Title: Advisory Committee on Reactor Safeguards
 Plant Operations and Fire Protection

Date: Tuesday, January 13, 2015

9 3. WBN Unit 2 Design, Licensing, and
10 Construction Activities

12 4. Hydrology Review - Open Items 133 and 134

Watts Bar Site on Tennessee River

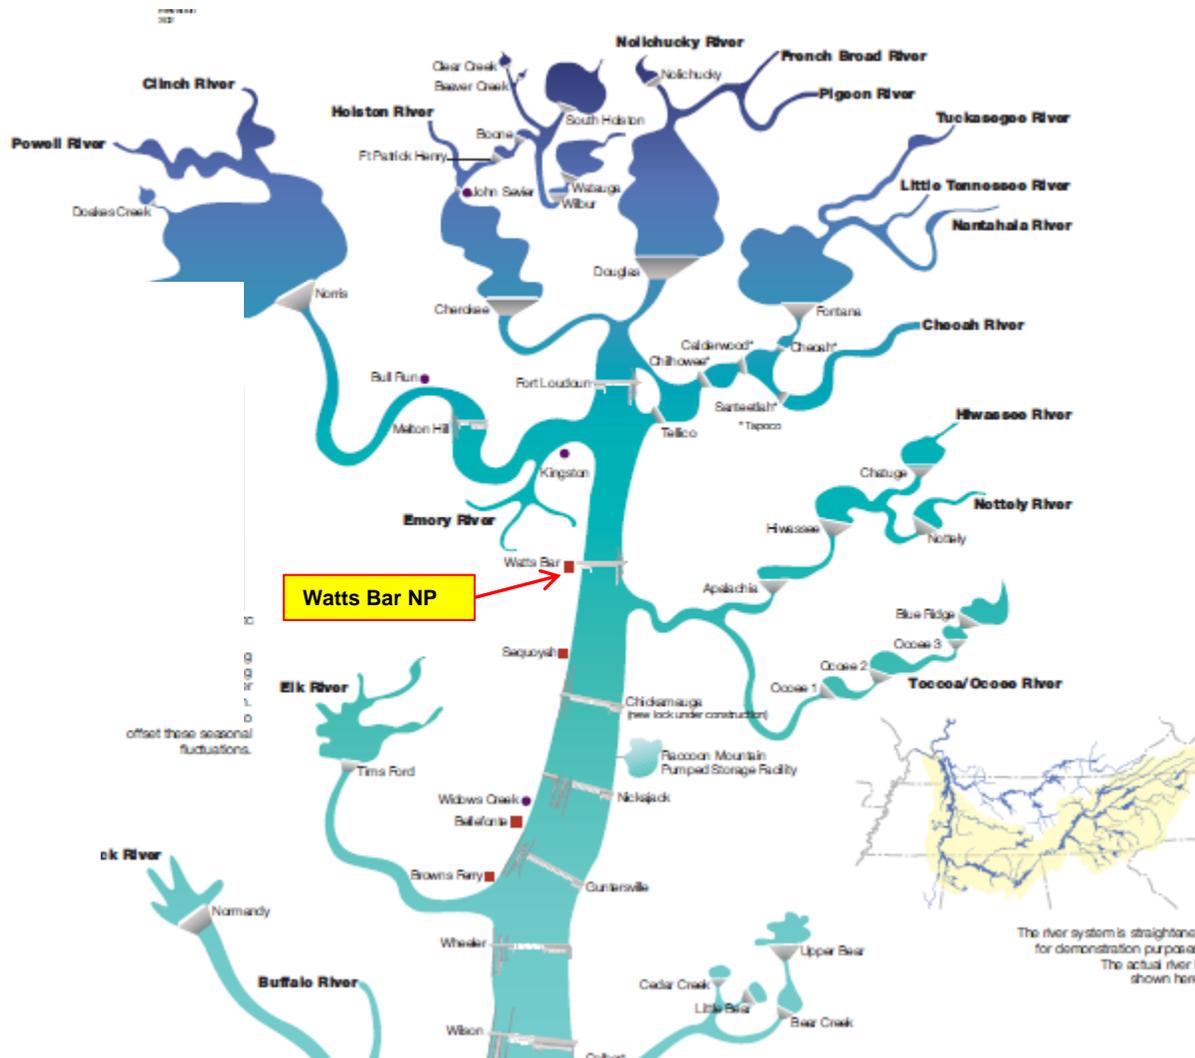
17 MR. MAULDIN: I would like to move on to
18 slide 9, if everybody is ready to move. This just
19 provides the lay of the land at Watts Bar site. Notice
20 the nuclear power plant in the lower center with the
21 plant grade elevation annotated. Just upstream of
22 Watts Bar Nuclear Plant is Watts Bar Dam in the upper
23 right-hand corner. Watts Bar Dam was built in '42,
24 1942. It is 112 feet tall. It has got a five-unit
25 powerhouse and a 60 by 360 foot lot.

7 I would note a couple of elevations. If
8 you compare the winter pool there in the tail water to
9 the plant grade elevation, there is about 46 feet of
10 elevation difference. And if you look at the
11 historical storms we referenced in the lower left-hand
12 portion, you will also see that those are well below
13 plant grade.
